ADDENDUM 2

PROJECT NAME: Southside Lions Park

PROJECT NO: 23-04021

E100

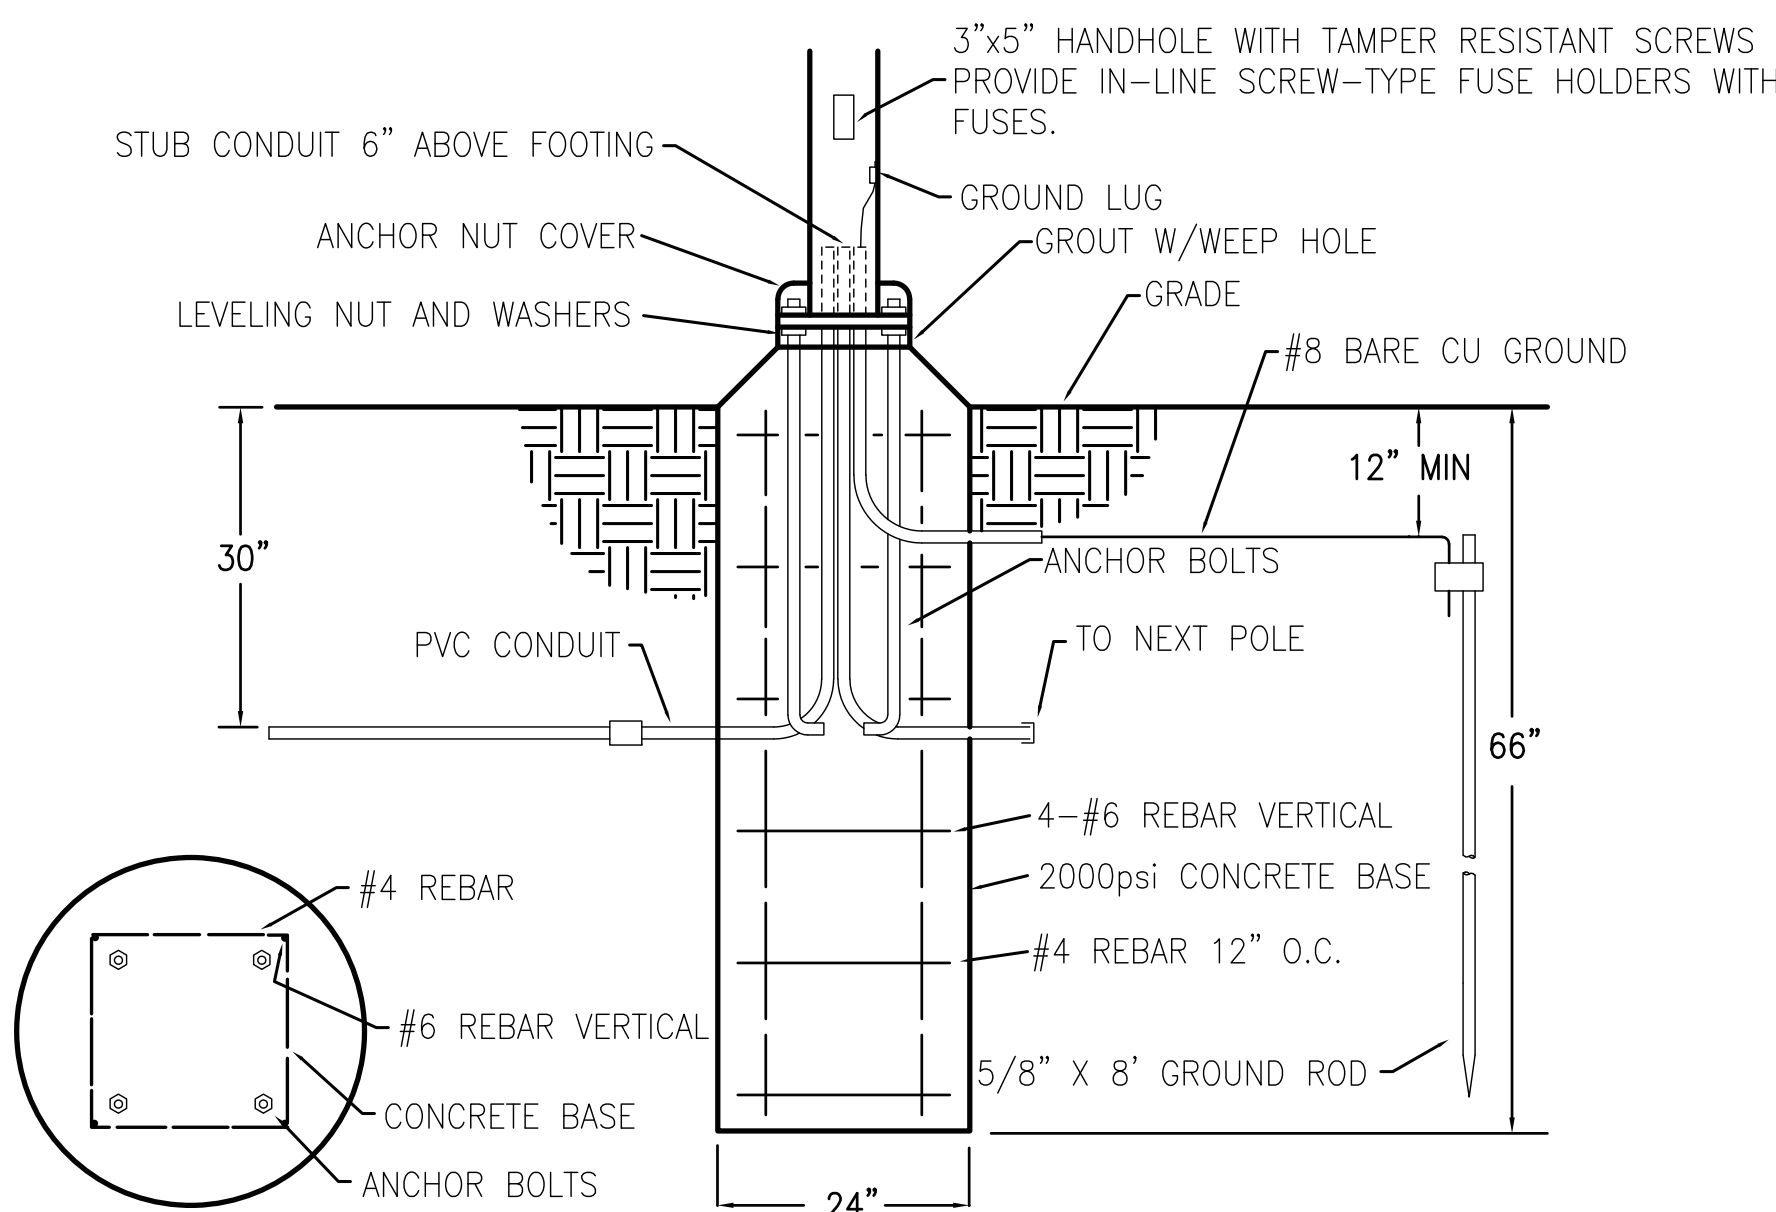
1. Sheet E100 has been revised. See attached Sheet E-100 dated 12-16-2024.

Question #12: luryElectrical sheet E100 is distorted especially in the area of the single line diagram and proposed new panel, could you please re-issue?

Answer: Revised Sheet E100 is attached as part of the Addendum.
